Staff Report

Site Plan Review

SP-25-24

Proposal:	The development of a new residential fourplex.
Review Body:	Staff (Type I-L review)
Property Owner:	Dahled Up Construction; 122 8th Street, Jefferson, OR 97352
Address/Location:	135/139 Hill Street NE
Map/Tax Lot:	Linn County Tax Assessor's Map No. 11S-03W-06DA; Tax Lot 900
Zoning:	Waterfront (WF)
Overlay Districts:	None
Total Land Area:	7,392 square feet
Existing Land Use:	Undeveloped
Neighborhood:	Willamette
Surrounding Zoning:	North: Waterfront (WF) East: WF South: Mixed Use Residential (MUR) West: WF/MUR
Surrounding Uses:	North: Single-dwelling Development East: Single-dwelling Development South: Multi-Dwelling Development West: Commercial and Single-Dwelling Development

SITE PLAN
135 & 139 HILL STREET NE

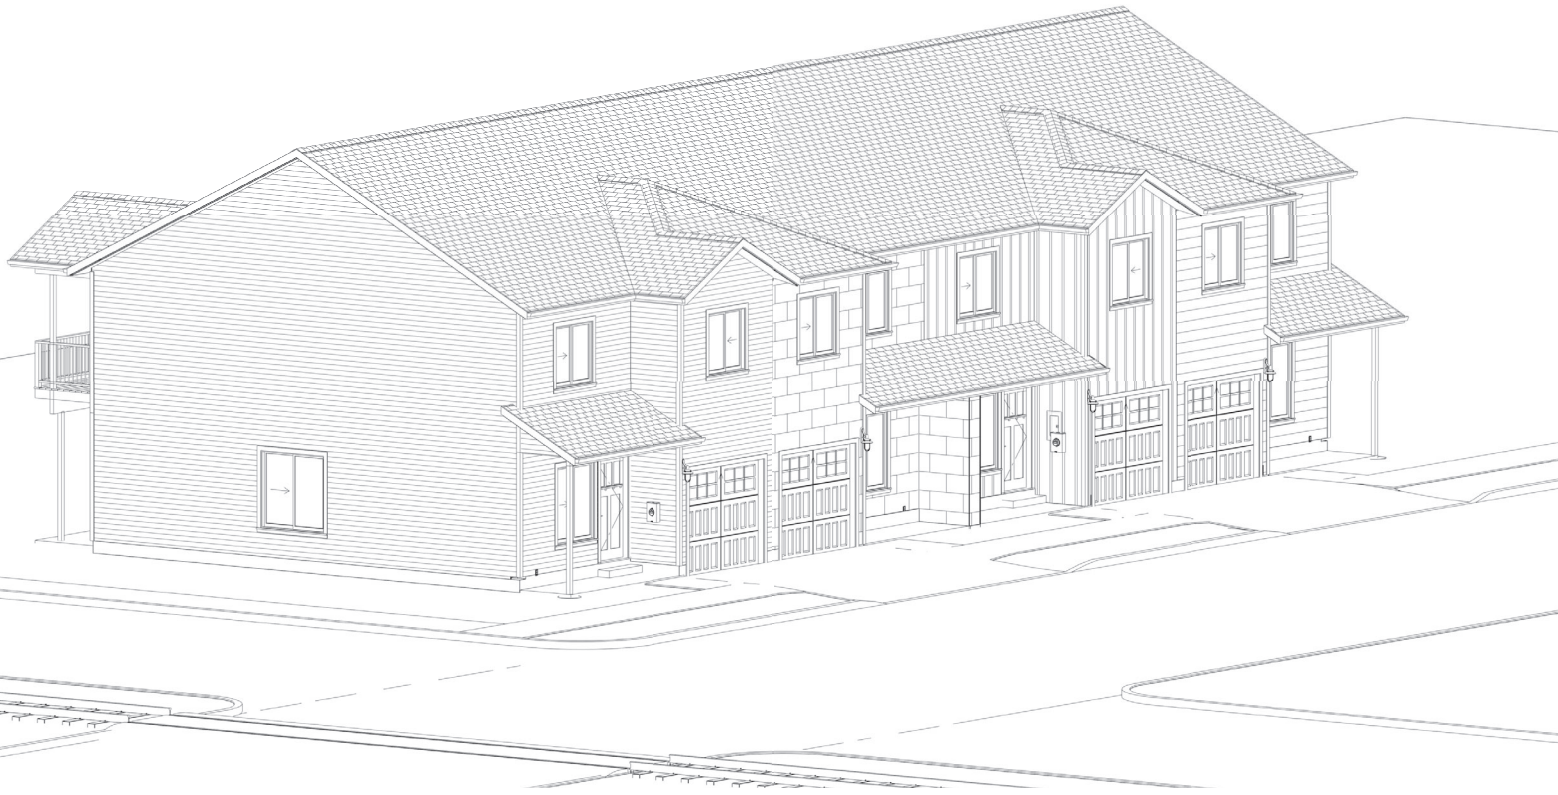
- 4.7 Based upon the submitted site plan (Attachment B) and building elevations (Attachment C) the applicant proposes to provide a street facing garage for each dwelling unit served by two shared driveways which are spaced approximately 23 feet apart. The proposed garages are setback five feet and are approximately 14 feet in width. As a condition of approval, the applicant must update the structural plans at building permit submittal where the garage does not exceed 12 feet in width. With the condition of approval, the application can meet this standard.

- 8.5 ADC 12.060 and 12.290 require all public streets adjoining new development be improved to City standards.
- 8.6 The site plan submitted by the applicant proposes two driveways off Hill Street and pedestrian connection to Water Avenue. The current driveway off Hill Street does not meet current standards and is 80 feet wide. The submitted site plan does not use the existing driveway off Water Avenue.

- 8.7 The applicant will need to remove the driveway approaches off Hill Street and replace with standard curb, gutter, sidewalk, and install two new standard driveway approaches. The applicant will need to remove the unused driveway off Water Avenue and replace it with standard curb and gutter. The location and design of the new approaches shall conform to the design standards contained in ADC 12.100.

Condition 1: At the time of building permit submittal, the building plans must limit the garage door width to 12 feet.

- Condition 6: Prior to the city issuing the final certificate of occupancy, the applicant shall remove the driveway approaches off Hill Street and replace with standard curb, gutter, sidewalk, and install two new standard driveway approaches. The applicant shall remove the unused driveway off Water Avenue and replace it with standard curb and gutter.
